**NUMBER:** 03-003-15**GROUP:** Differential &  
Driveline**DATE:** September 02, 2015

Front Of Vehicle Lateral Vibration During Low Speed Acceleration

2014 - 2015 (KL)

Jeep Cherokee

**Fig. 1 Axle Half Shaft Identification**

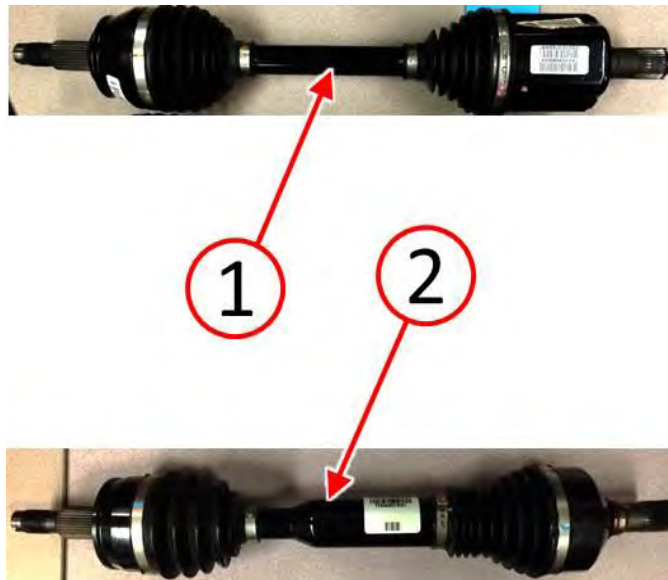
1. Inspect the front axle half shafts to identify which type is currently installed in the vehicle? Refer to (Fig. 1).
  - a. Straight Diameter Center Shaft (1) (Fig. 1)>>> Continue with the Repair Procedure Step #2.
  - b. Stepped Diameter Center Shaft (2) (Fig. 1)>>> This Bulletin does not apply. Normal diagnosis should be performed.

2. Remove the front half shafts with straight diameter center shaft and replace with the stepped diameter center shaft half shafts listed in this bulletin. Refer to the detailed service procedures available in DealerCONNECT> TechCONNECT under: Service Info> 03 - Differential and Driveline> Half Shaft, Front> Removal/Installation.
